MODIFICATION INSTRUCTIONS
for the
***Kodak X-Omat* MULTILOADER 300**
Service Code: 3058
Modification No. 41/43
***Kodak X-Omat* 270 RA PROCESSOR**
Service Code: 3059
Modification No. 23/24
***Kodak X-Omat* 180 LP/180 LPS PROCESSORS**
Service Codes: 3227, 3198
Modification No. 10/12

- Purpose:** To upgrade the DRYER RACK with new RACK SIDEPLATES to improve reliability.
Mods 10/23/41 will:
- improve the film path by making changes to the positions of the "F" and "E" ROLLERS.
 - make changes to the diameter of the new "F" and "E" ROLLER GEARS.
 - make the bottom GUIDE SHOE adjustable.
 - include new SIDEPLATE BEARINGS which have a longer service life.
- Mods 12/24/43 will:
- reduce wear and binding in the RACK by installing new BEARING WASHERS.

Figure 2 AIR TUBES, GUIDE SHOE, and CAPTIVE BRACKETS - Drive Side View

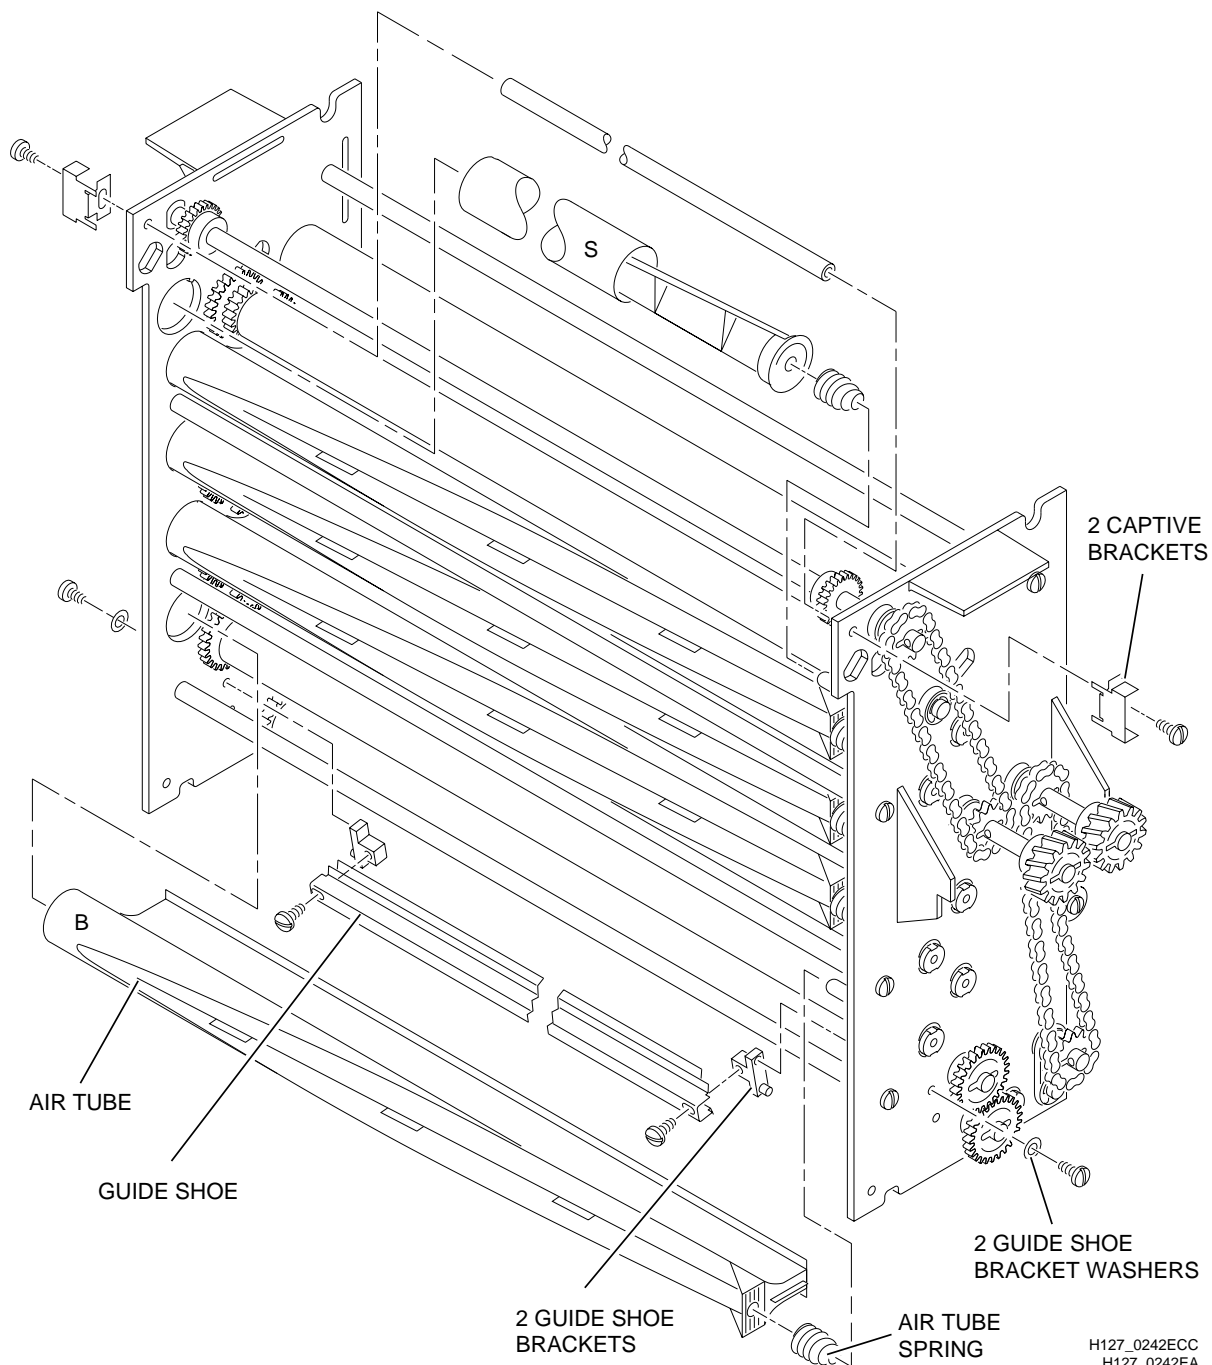
[4] See Figure 2. Install the parts removed in Step 4 on Page 5.

- use new SCREWS 544267 and WASHERS 852611 to install the bottom GUIDE SHOE BRACKETS on the SIDEPLATES.
- check that the long edge of the bottom GUIDE SHOE is in the direction of the film path.

Figure 3 **SIDEPLATES, ROLLERS, and GEARS - Drive Side View**

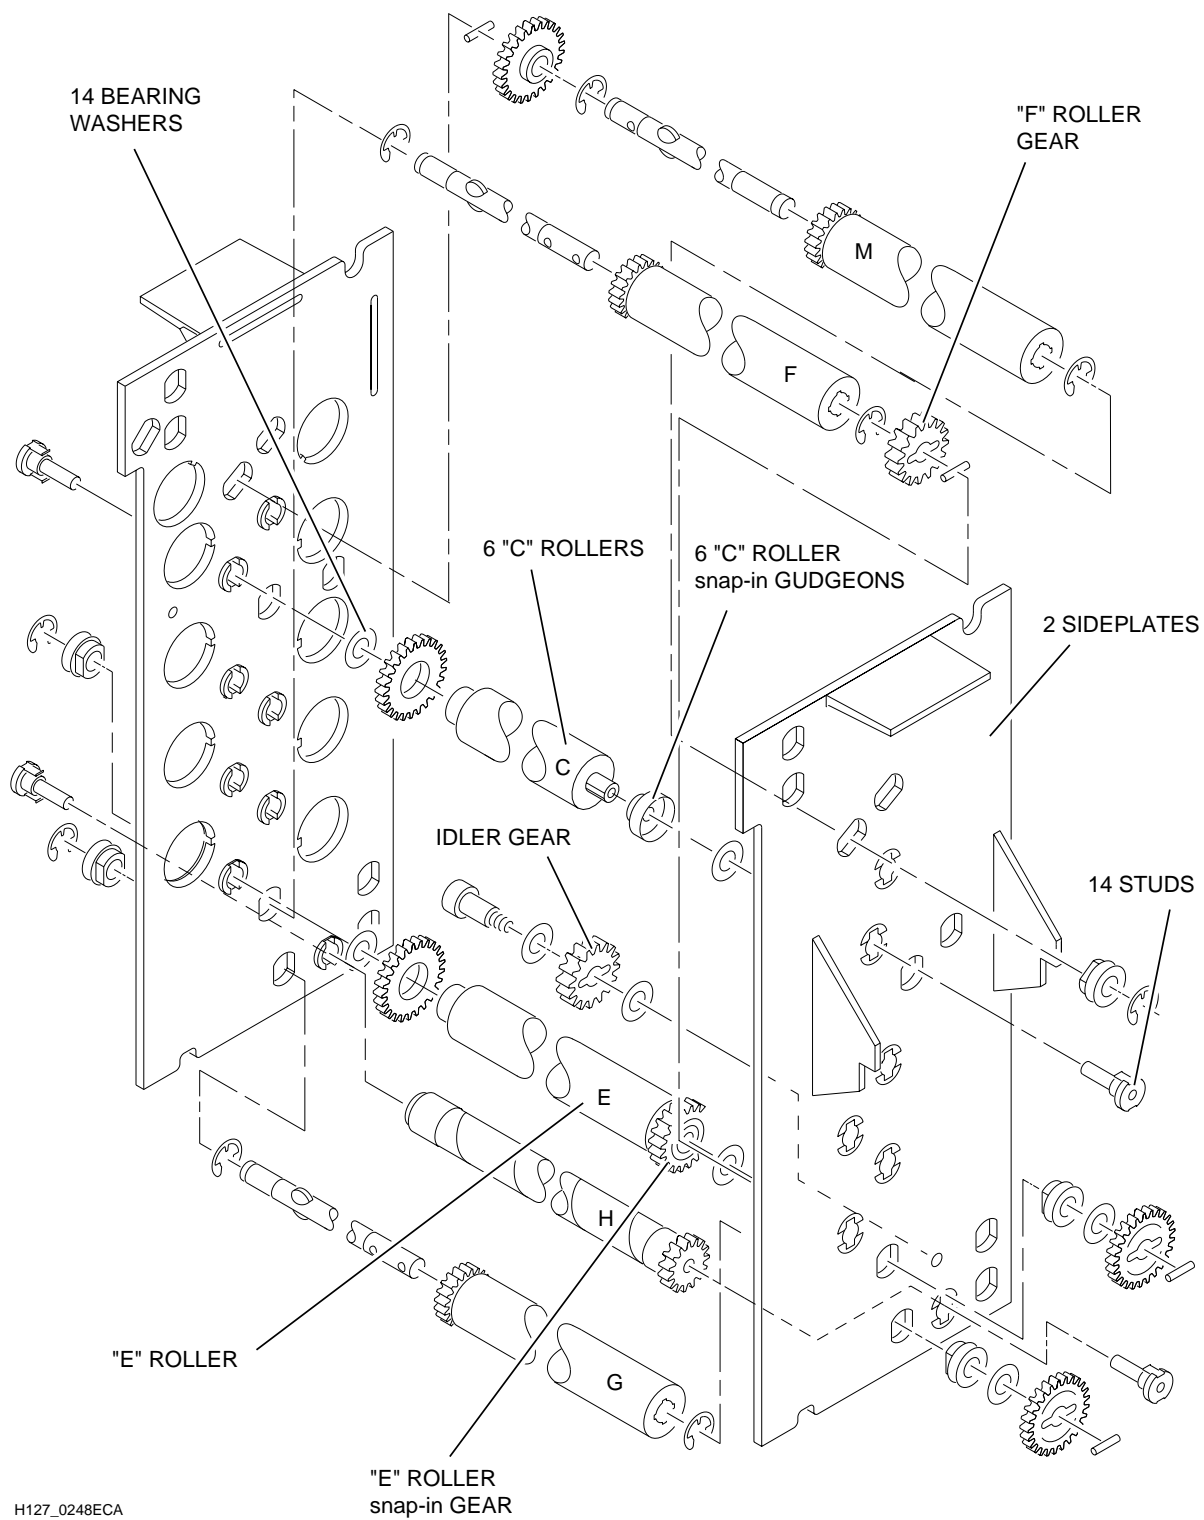
[6] See Figure 3. Remove and discard:

- existing GEAR from the “F” ROLLER (drive side)
- existing snap-in GEAR from the “E” ROLLER (drive side)
- 6 snap-in GUDGEONS from the 6 “C” ROLLERS

[1] See Figure 3. Install the new snap-in “E” ROLLER GEAR 1C7244 on the “E” ROLLER.

- the parts removed in Step 5 on Page 8.
- the new BEARING WASHERS, one on each end of each “C” ROLLER between the SIDEPLATE and the end of the ROLLER.
- the new “F” ROLLER GEAR 1C7245 (located inside the SIDEPLATE) on the “F” ROLLER.

Figure 4 SIDEPLATES, DRIVE CHAIN, and SPROCKETS - Drive Side View

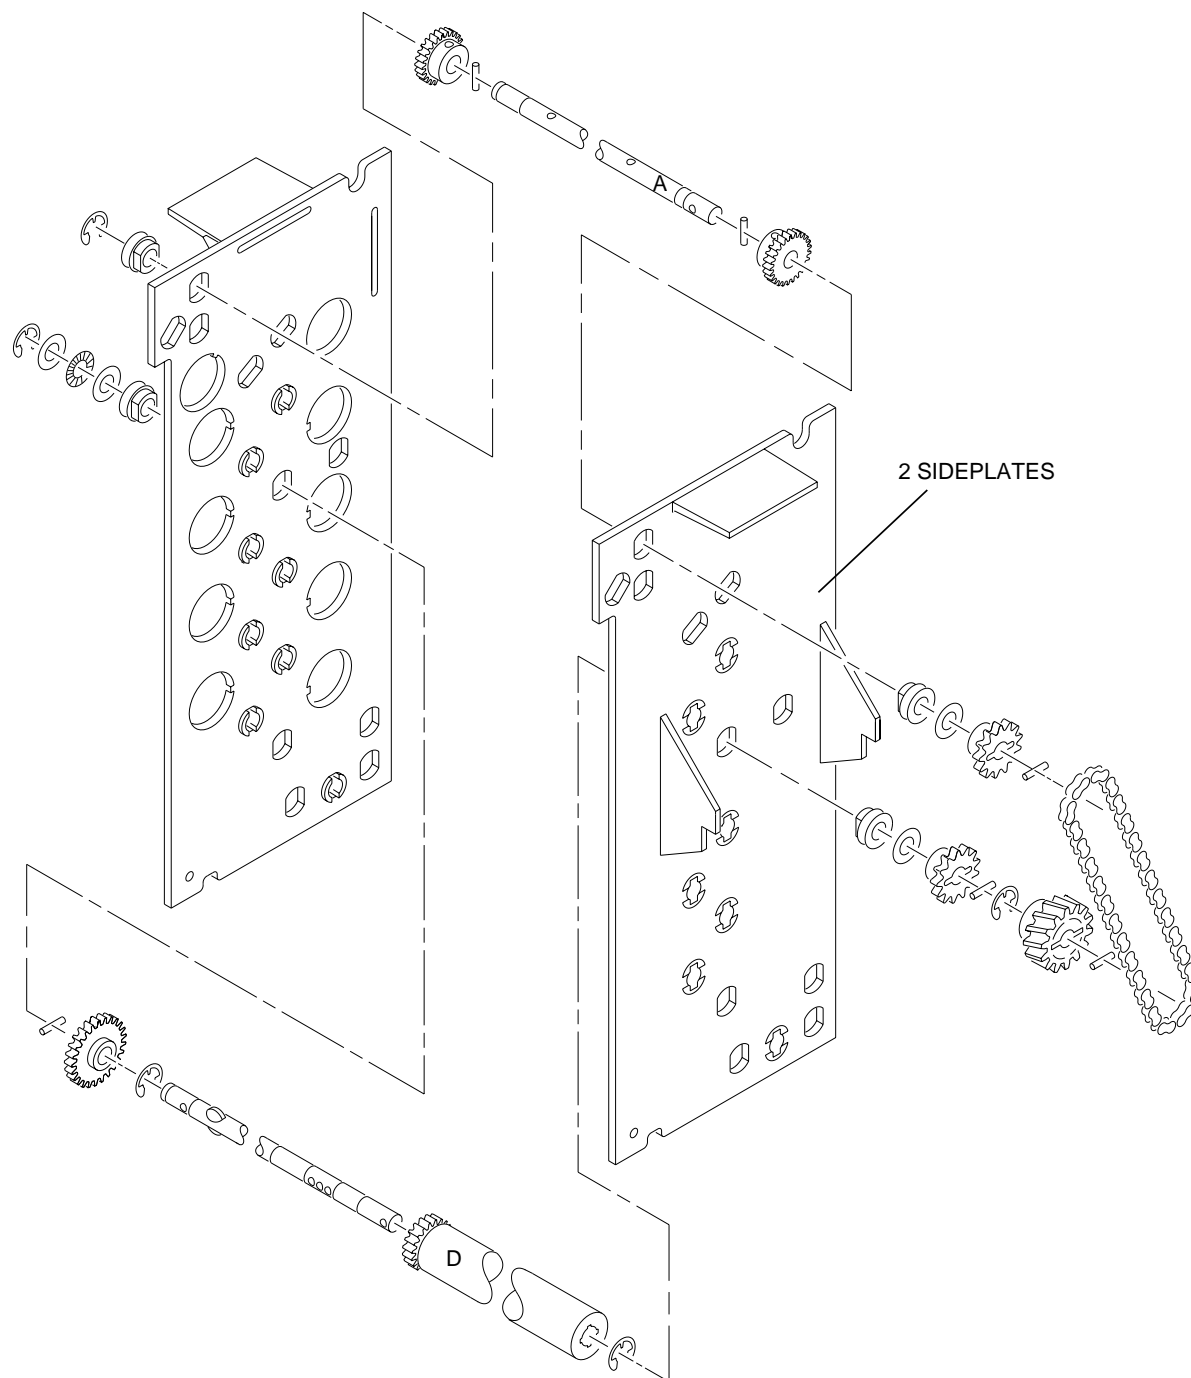
[2] Remove the CHAIN IDLER SPROCKET in Figure 5 and the IDLER GEAR in Figure 4 from the old SIDEPLATE and install them on the new drive side SIDEPLATE.

Figure 6 **GUIDE SHOE**

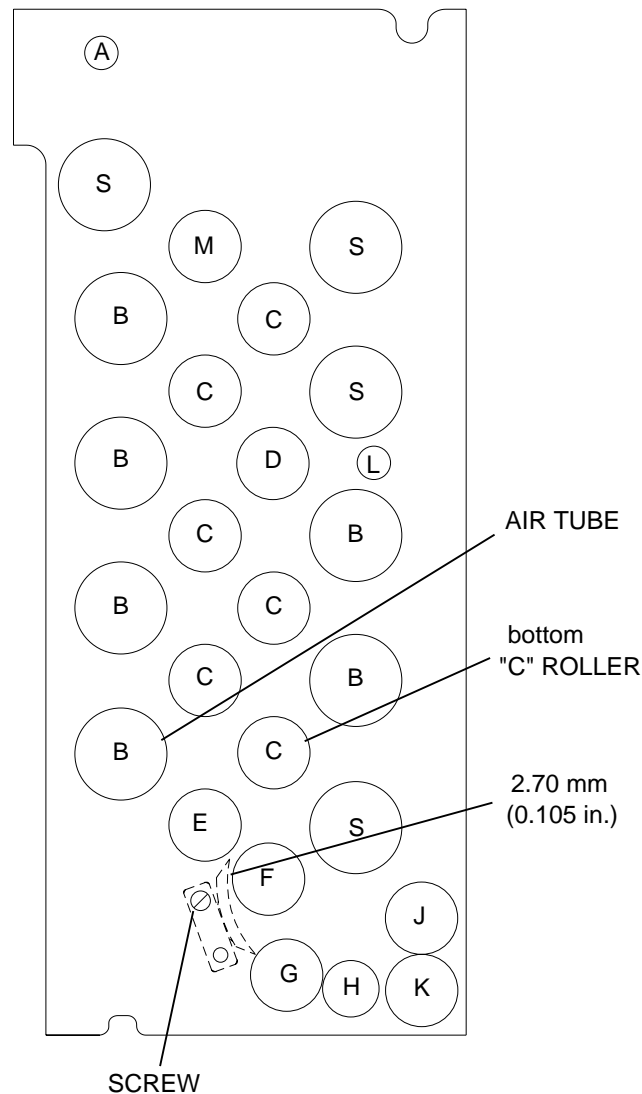
[5] See Figure 6. Loosen the SCREWS.

[6] Set the distance between the “F” ROLLER and the GUIDE SHOE:

- (a) Place a 2.70 mm (0.105 in.) FEELER GAUGE between the “F” ROLLER and the long edge of the GUIDE SHOE. See Figure 6.
- (b) Hold the GUIDE SHOE against the FEELER GAUGE and tighten the SCREWS.
- (c) Check that the clearance between the GUIDE SHOE and the ROLLER is 2.70 mm (0.105 in.) +/- 0.10 mm (0.005 in.) at both ends and in the center.

- for scratches, **increase** the distance approximately 0.10 mm (0.005) between the GUIDE SHOE and the “F” ROLLER.
- for stubbing, **decrease** the distance approximately 0.10 mm (0.005 in.) between the bottom GUIDE SHOE and the “F” ROLLER.
- after making the adjustment, check for film quality by processing the film. Do the above procedures again as necessary, to minimize the film scratching or stubbing.
